ADDENDUM NO. #0

TRACK & FIELD IMPROVEMENTS

Rio Mesa High School

April 10, 2020

AD0-C8

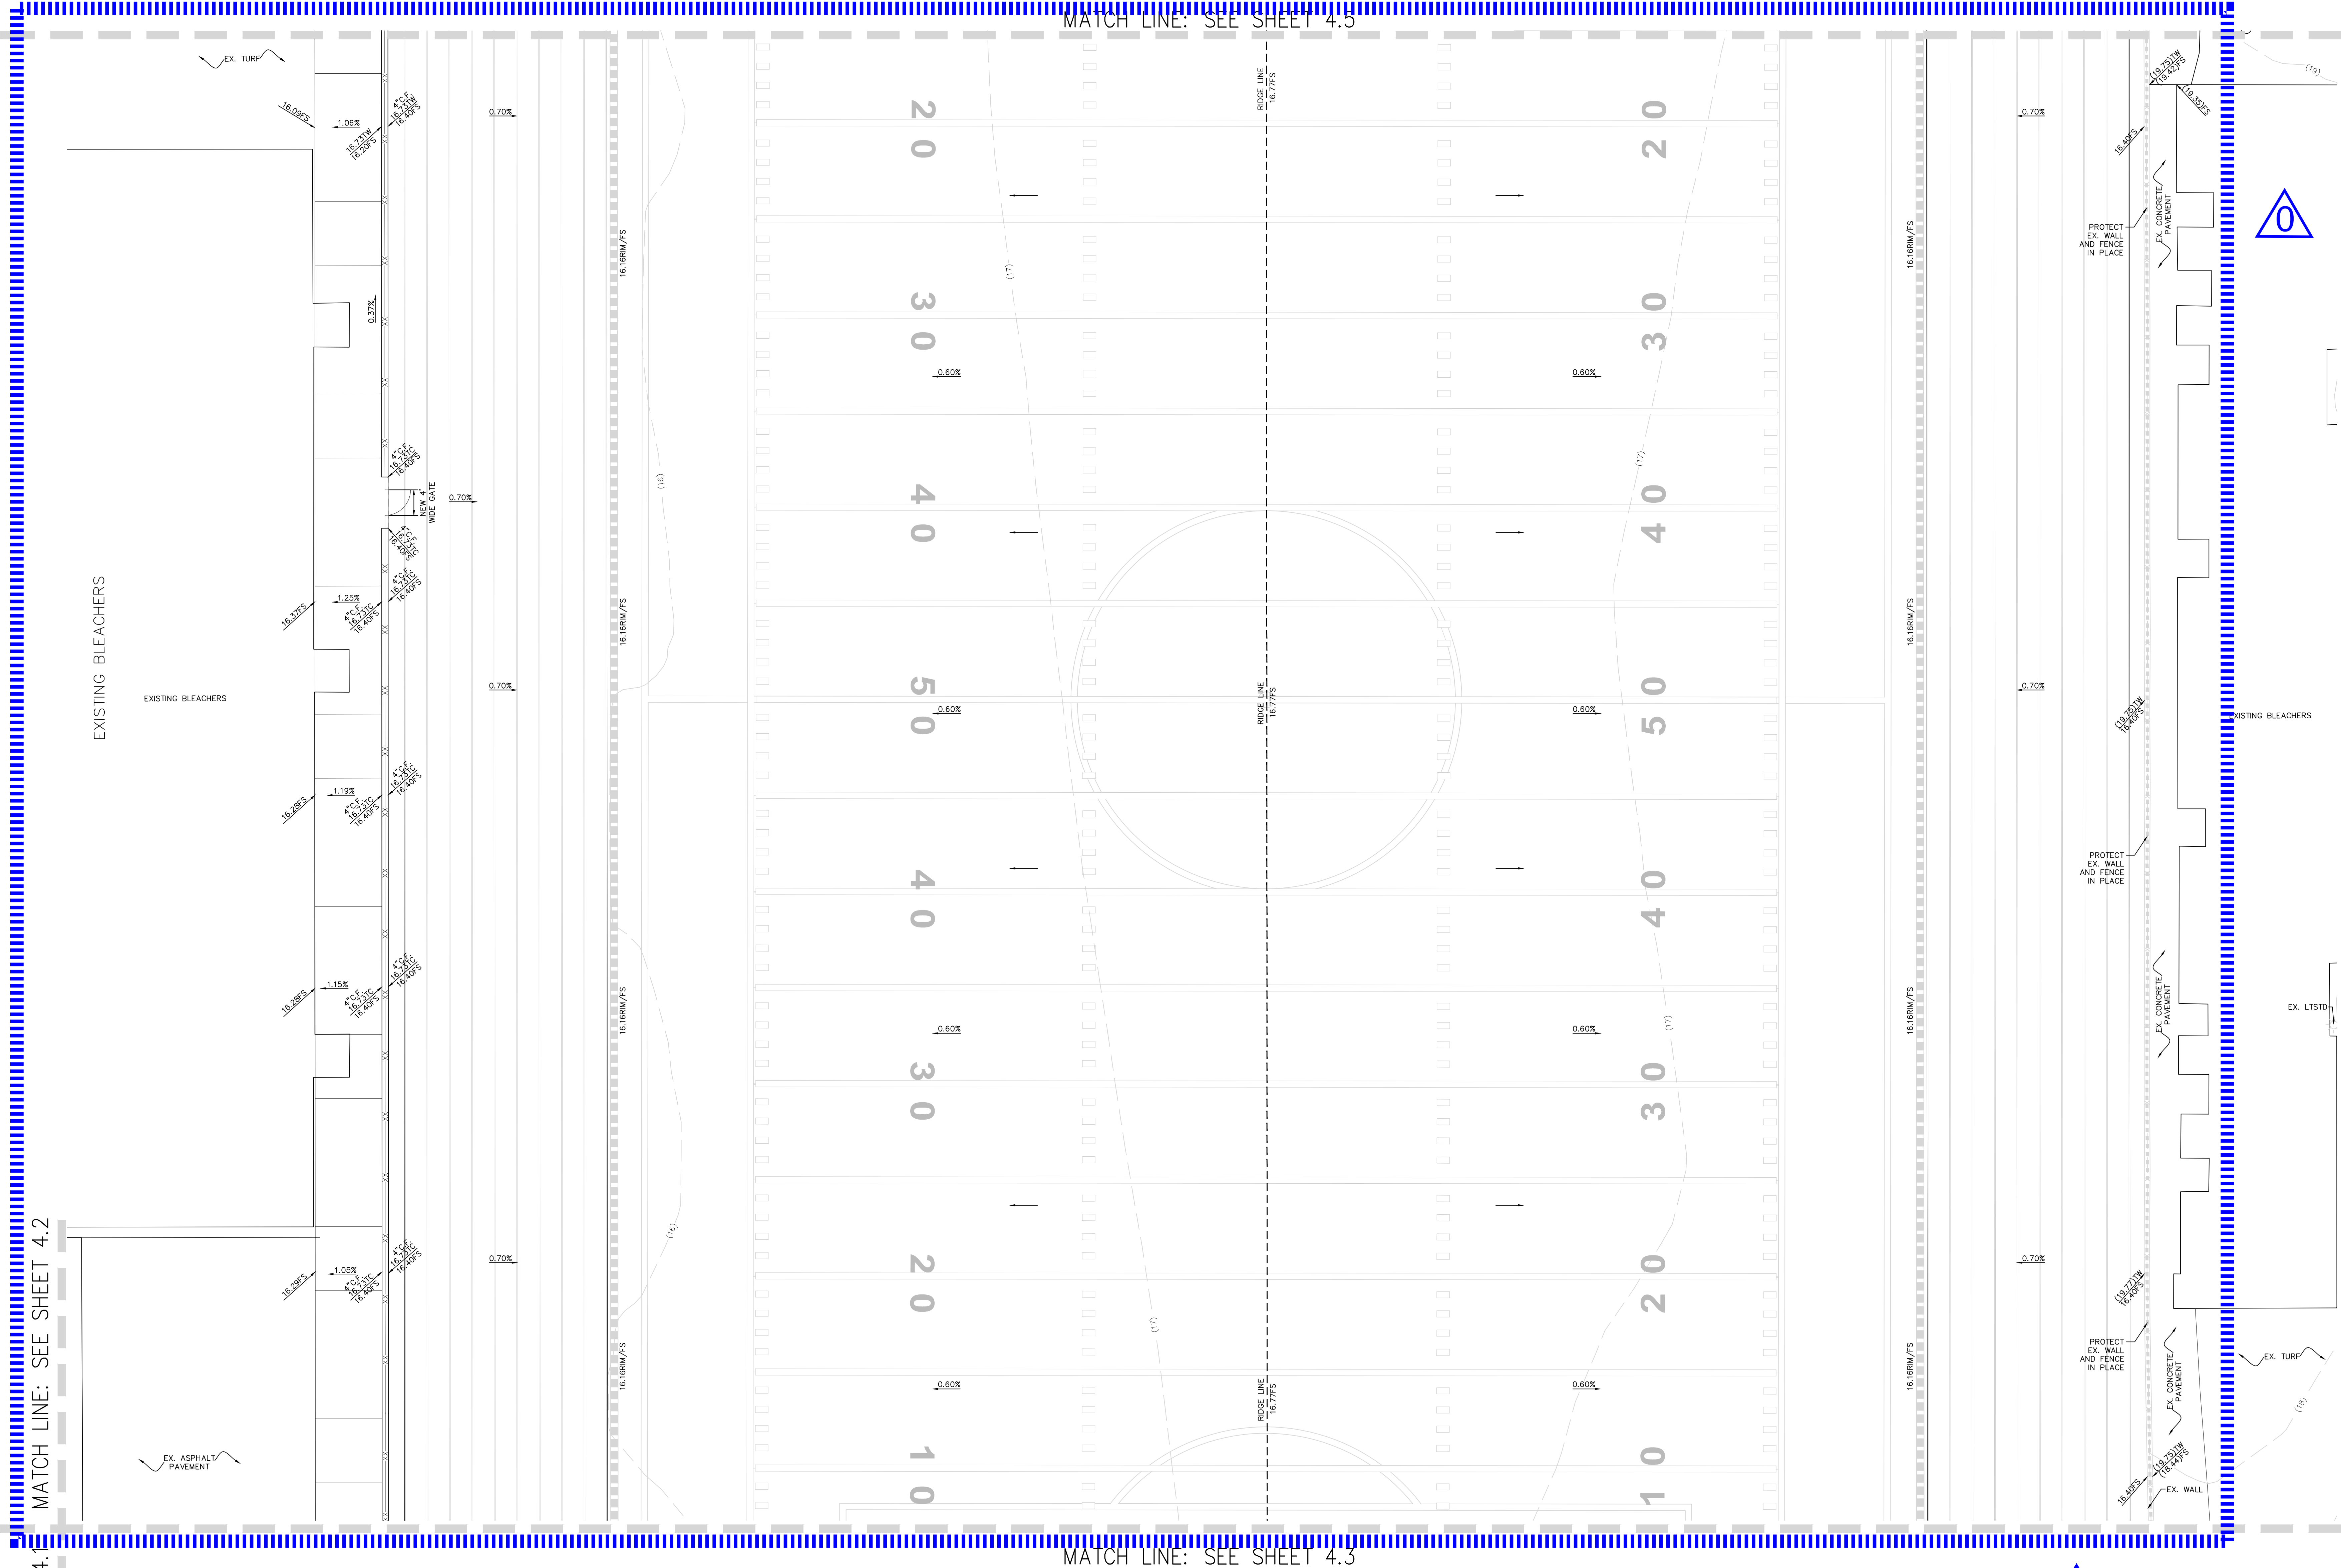
- 3.1.2.8.** Drawing C4.3/AD0-C8 - Only work within outlined area is included in scope of this project and bid. Any work shown outside of the delineated area is not part of this project.

SHEET NUMBER
C4.4 AD0-C9

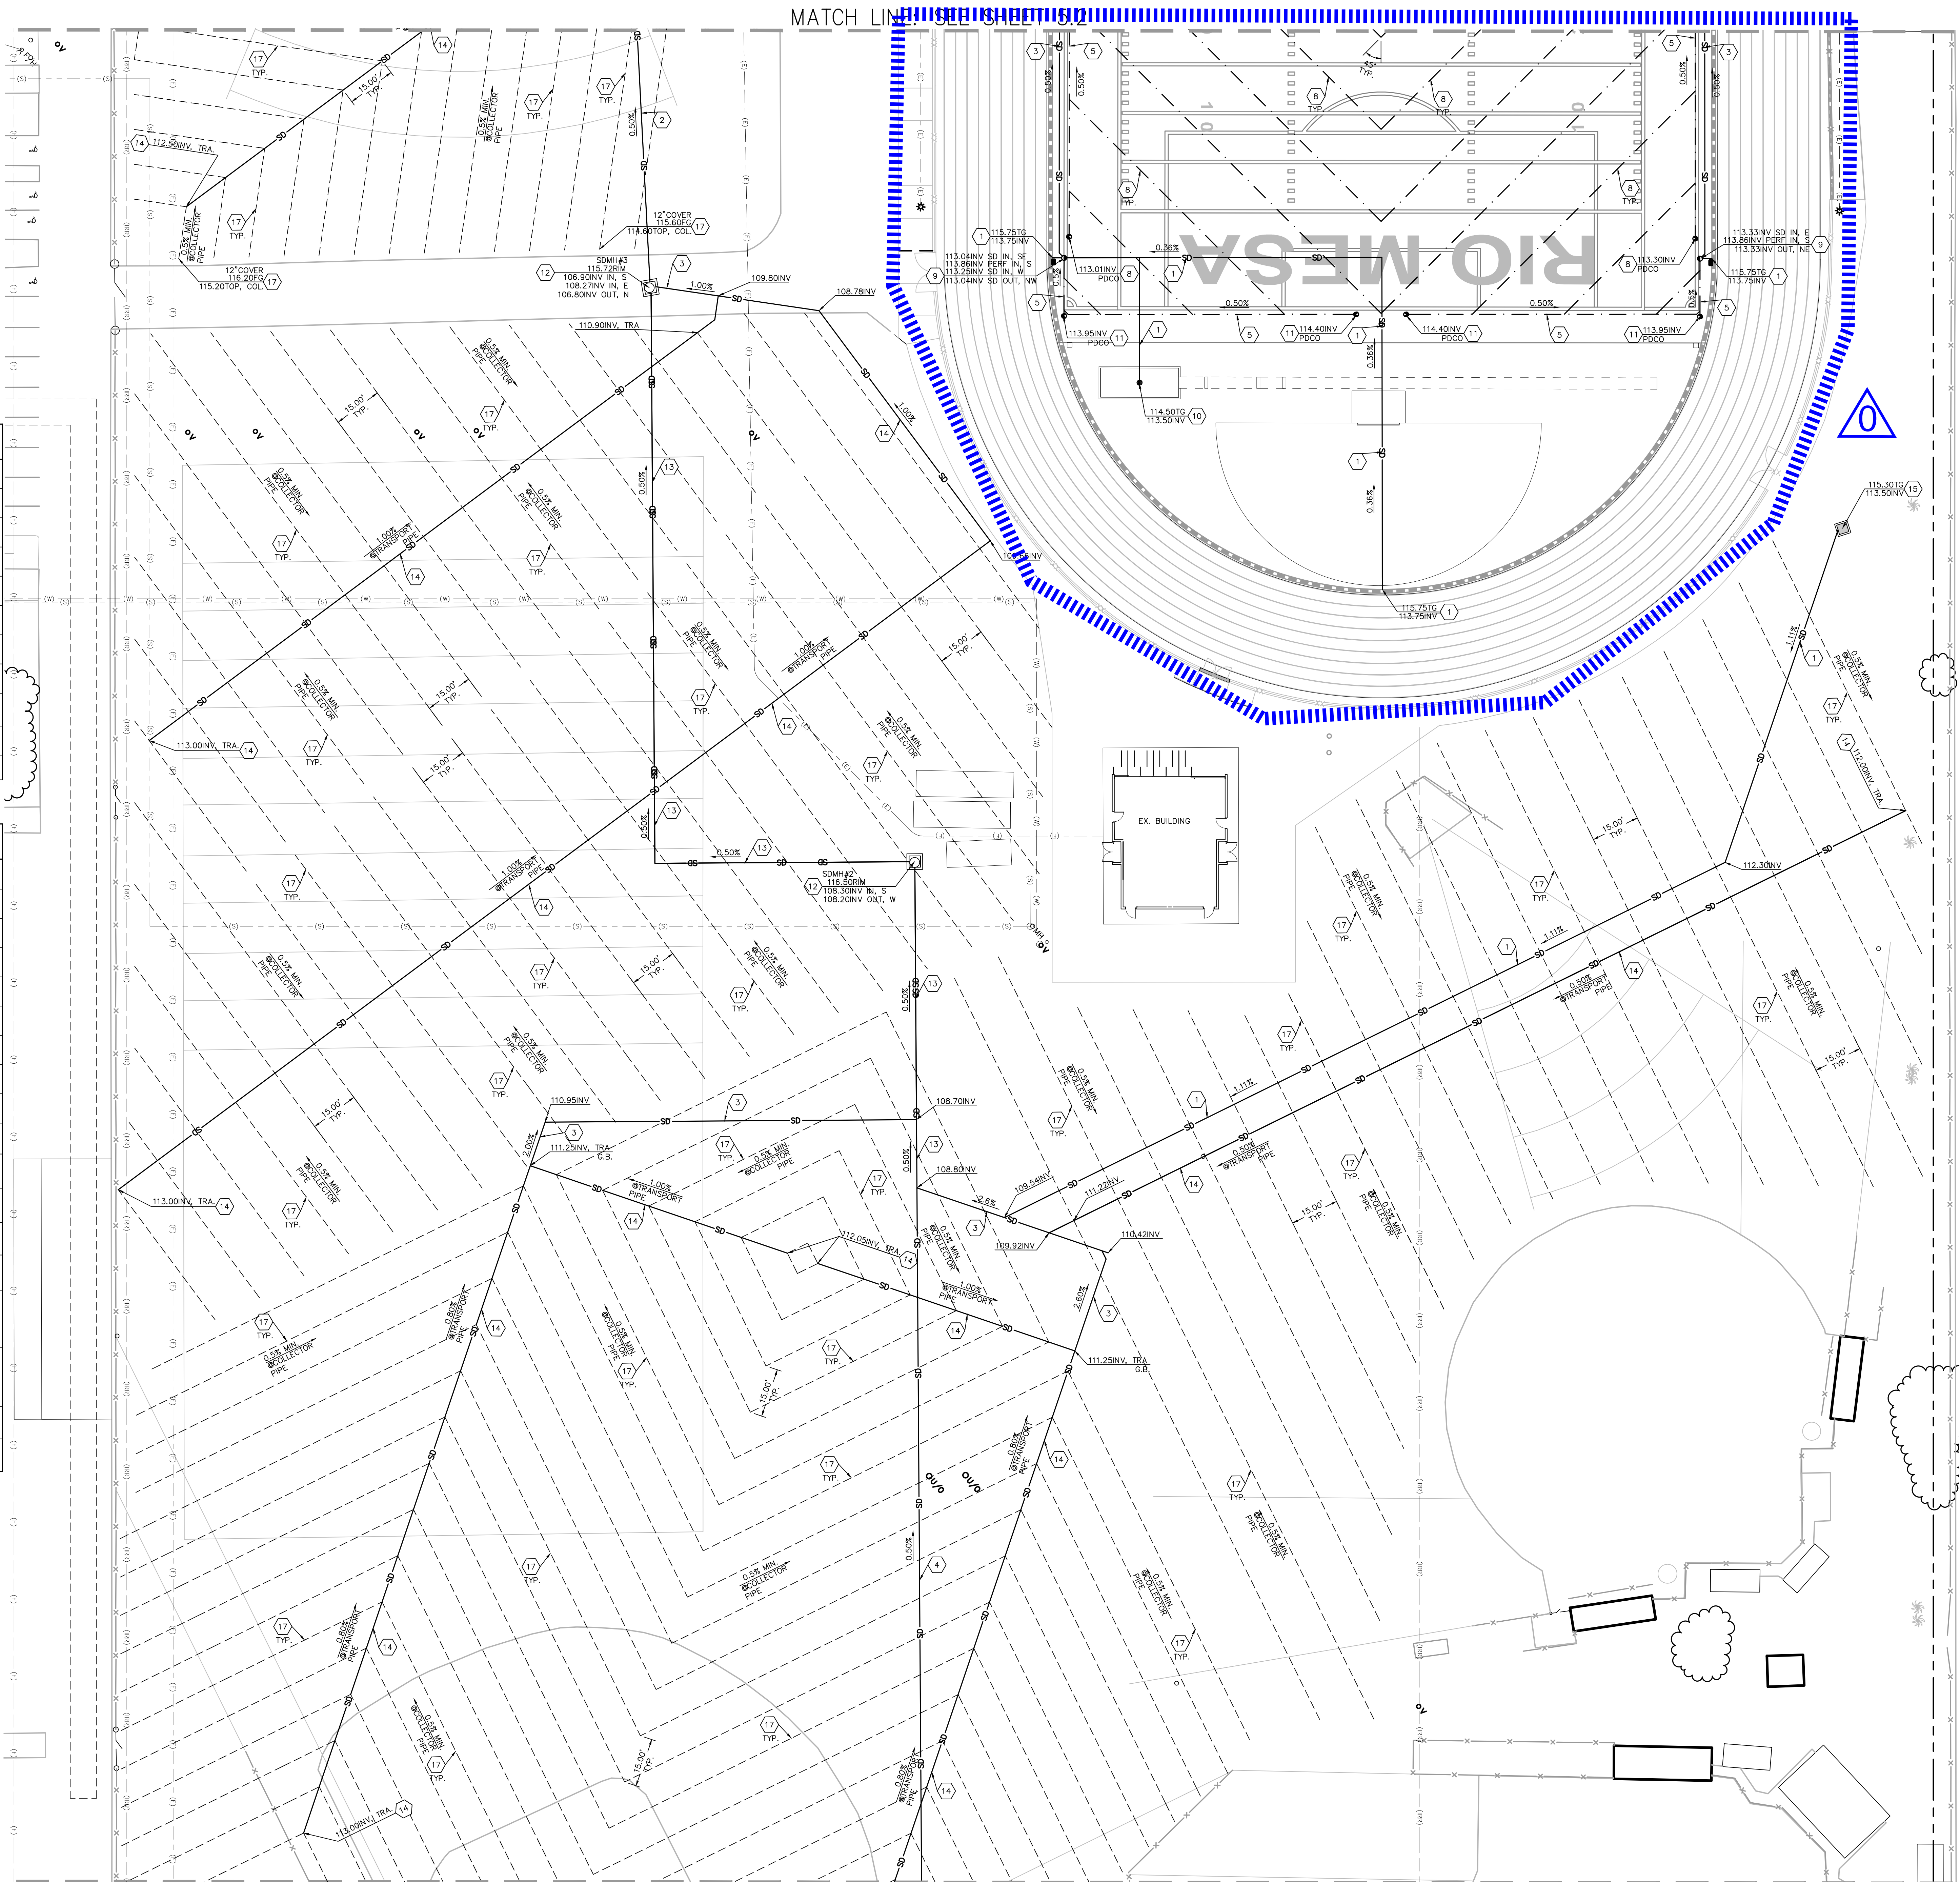
- 3.1.2.9.** Drawing C4.4/AD0-C9 - Only work within outlined area is included in scope of this project and bid. Any work shown outside of the delineated area is not part of this project.

AD0-C13

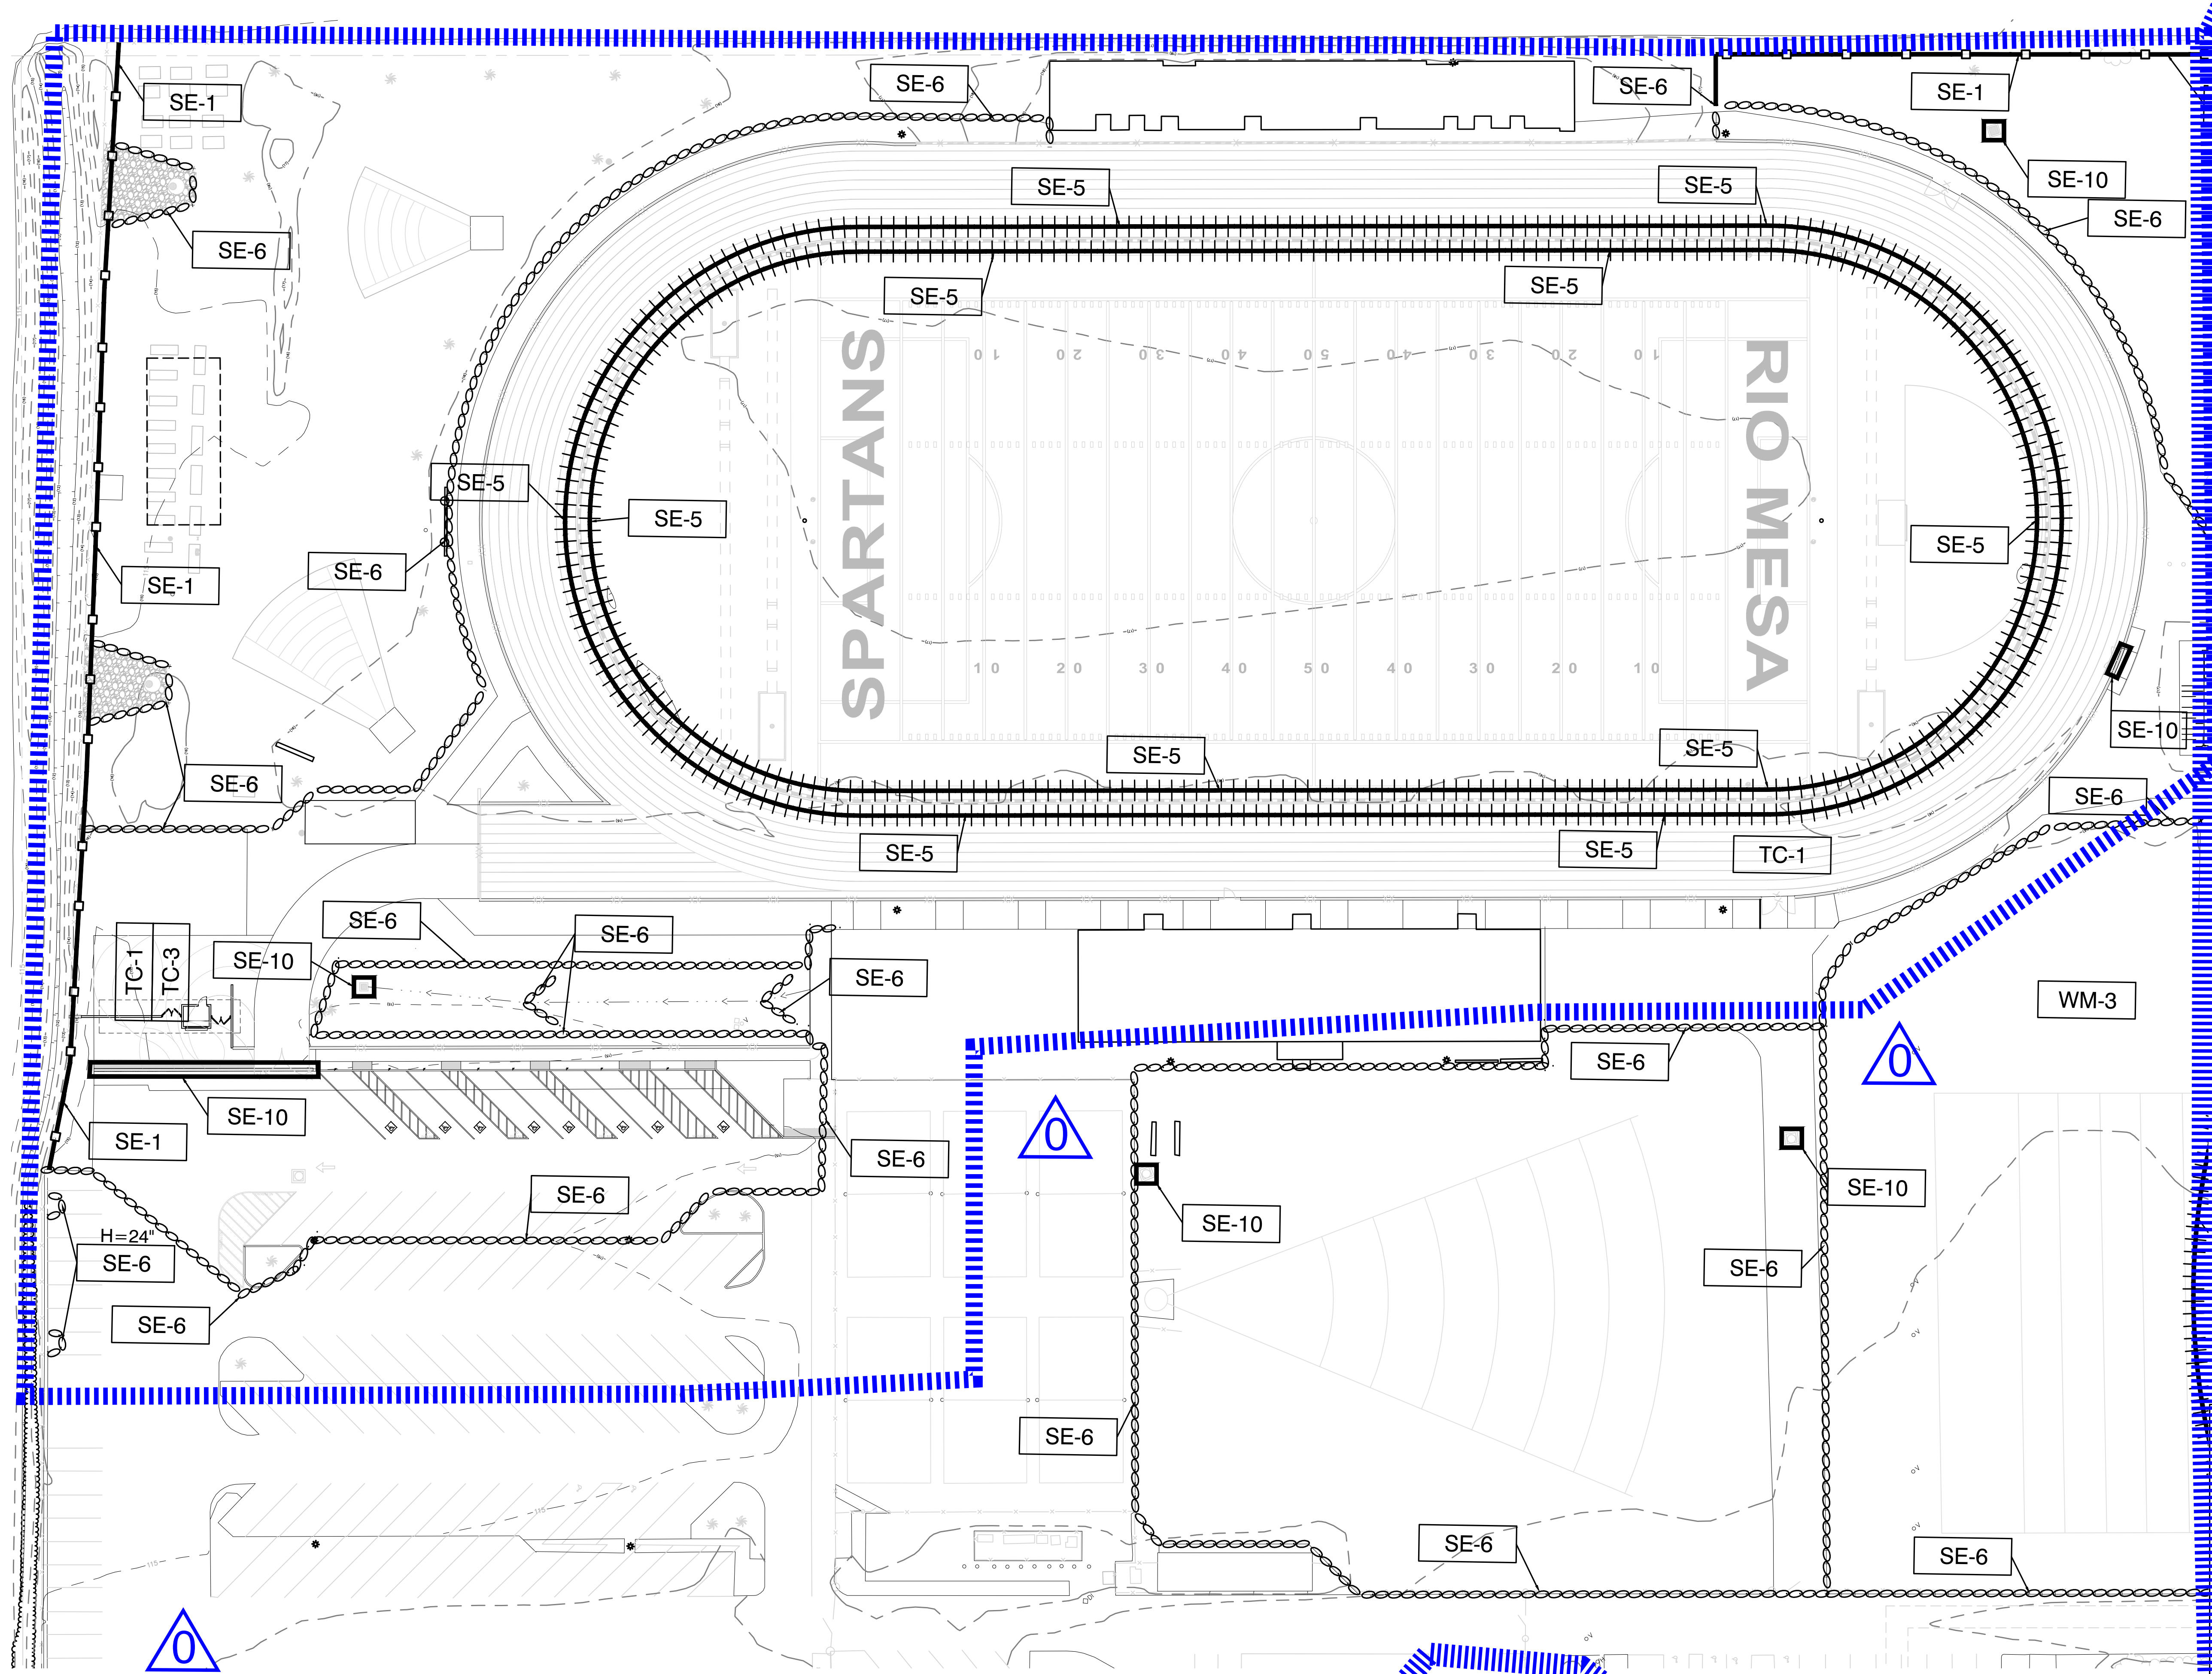
- 3.1.2.13.** Drawing C5.2/AD0-C13 - Only work within outlined area is included in scope of this project and bid. Any work shown outside of the delineated area is not part of this project.
